# APPLICANT'S RESPONSE TO INTERESTED PARTIES' DEADLINE 2 SUBMISSIONS: 9.17

## Cory Decarbonisation Project

PINS Reference: EN010128

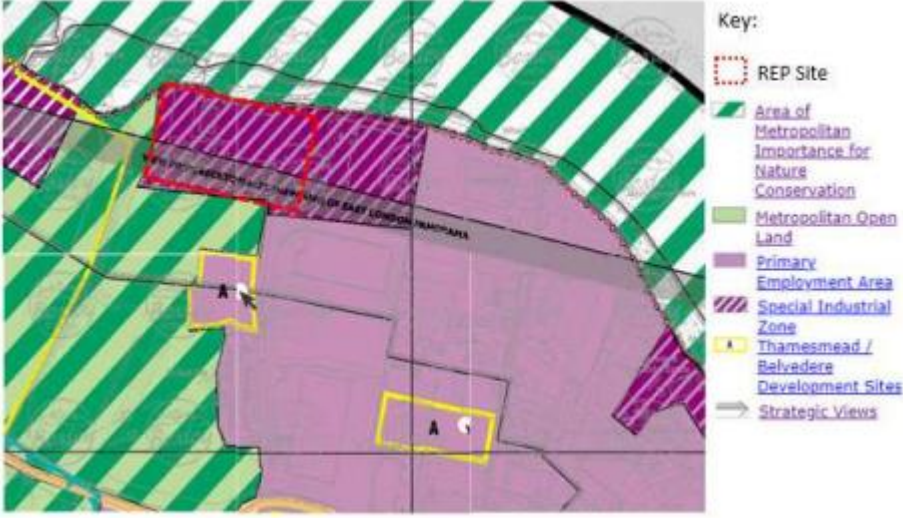
2.5.5	6. We add that a relocation of FP4 along the southern and eastern edges of North Zone 1 (as shown in red in Figure 1 below) would allow for a more efficiently designed site in East Zone (North Zone 1). While we do not consider this change necessary, it would make it even more feasible to avoid impact to third parties, allow for a contiguous site, and also facilitate access to and from Norman Road. It would also minimise impact on users of FP4, as detailed below.	The relocation of FP4 as suggested by SCNR is not a reasonable alternative.  SCNR relies upon North Zone 1, which was demonstrated in the <b>TSAR Addendum (AS-044)</b> to perform poorly against the Optioneering Principles and consequently fail to meet the Principles and Objectives of the Proposed Scheme. It has been dismissed as a reasonable alternative.  As confirmed on page 125 of the <b>Applicant's Response to Interested Parties' Deadline 1 Submissions (REP2-019)</b> (the final paragraph of the second row under title 'Applicant's

2.5.21	<p>22. The fact that a small part of FP4 would “feel significantly more industrial in character” is of minor concern, and to be expected when surrounded by SIL. Furthermore, as per Figure 1 above, these concerns could be improved through a rerouting of FP4 along the southern and eastern edges of the Carbon Capture Facility.</p>	<p>As set out at <b>page 127</b> of the <b>Applicant's Response to Interested Parties' Deadline 1 Submissions (REP2-019)</b> in response to the SCNR and under title 'Analysis of Project Objectives in the East Zone' the '<i>Applicant does have concerns about the permanent effects that would likely impact FP4 if the Carbon Capture Facility were to be developed at the East Zone (as set out at <b>Appendix D to the Written Summary of the Applicant's Oral Submission at ISH1 (REP1-025)</b>. However, and as is explained in that Appendix, this is not the only concern with this location, which are discussed further in response to the SCNR's analysis.'</i></p> <p>The Applicant has confirmed, at <b>reference 2.5.5</b> above, that the SCNR's proposed relocation of FP4 is neither practical nor does it lead to a reasonable alternative.</p>

Table ref	Summary of issue raised	Applicant's response
		<p>approach to East Zone') even if the Compressed/Compact Layout could be delivered on a site of 6.3ha; it would still require the Iron Mountain plot and one other, with all the challenges that have been set out in the <b>TSAR (APP-125)</b>, the <b>TSAR Addendum (AS-044)</b> and <b>Appendix D of the Written Summary of the Applicant's Oral Submission at ISH1 (REP1-025)</b>.</p> <p>Development of the Carbon Capture Facility in the East Zone would require either Iron Mountain and Lidl land plots or Iron Mountain and ASDA land plots.</p> <p>In either outcome, neither of which are reasonable alternatives for reasons set out in the above-named documents including those in addition to the impact on FP4, the relocation of FP4 as suggested by SCNR would run through the development. This is neither a practicable outcome nor a reasonable alternative.</p>
